## MerCruiser Generation III Cool Fuel Module

**NOTICE**

Revised September 2017. This bulletin supersedes the previous bulletin number 2014-07R1 January 2015.

### Cool Fuel module

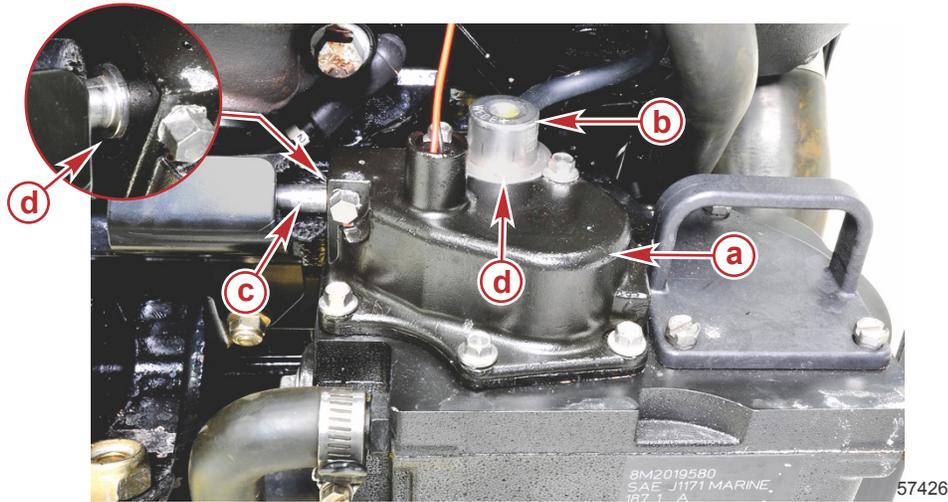
A situation has been identified whereby fuel may weep or very slowly leak from either the area under the fuel pressure regulator or at the joint between the Gen III Cool Fuel module and the discharge fuel line that carries fuel to the fuel rail, in the products listed above.

If you encounter the above condition, thoroughly inspect the areas around the fuel pressure regulator, discharge fuel line, and below the Gen III Cool Fuel module for the accumulation of fuel residue.

If signs of fuel weepage are observed at the inspection points, replace the Gen III Cool Fuel module top cover and seal, fuel pressure regulator, and the discharge fuel line quad ring. These components are available as a kit; order part number 8M0130861.

The new Gen III Cool Fuel module top cover is now anodized.
